Orderable: N/A	Designed for: Public Release	Mod. Date: 6/1/2016	 http://www.ti.com © Texas Instruments
TID #:	Project Title: 400V to 12V/500W LLC W/ UCD3138A	Sheet Title:	
Number: PMP20289	Rev: A	Assembly Variant: 001	
SVN Rev: Version control disabled	File: PMP12047_BlankSheet.SchDoc	Size: B	
Drawn By:	Contact: http://www.ti.com/support

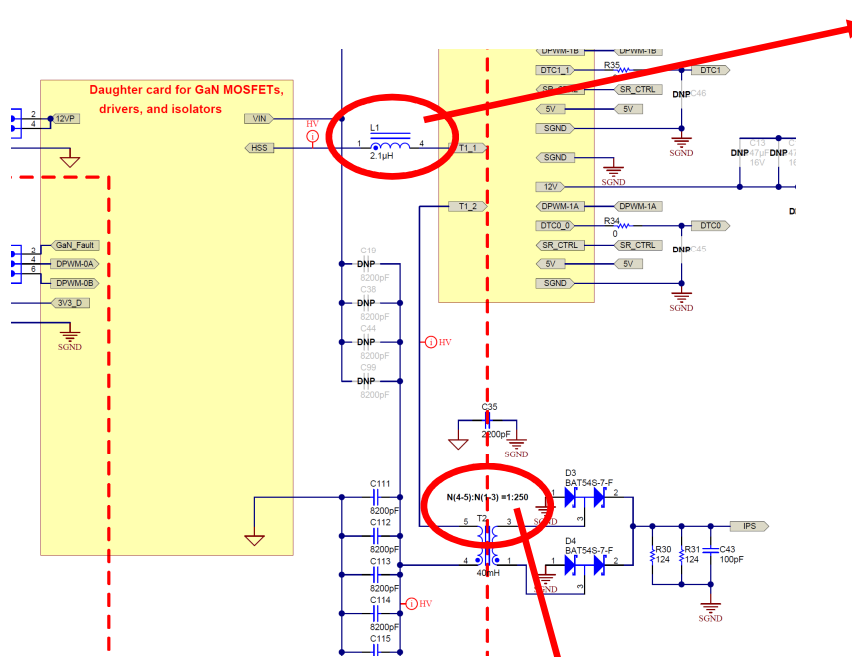
Ipri is low, so why have 250:1 ratio
Is it a typo?
In other TI documents, one sees
25:1 mostly

How to calculate this low a value? At what freq does one calculate this?
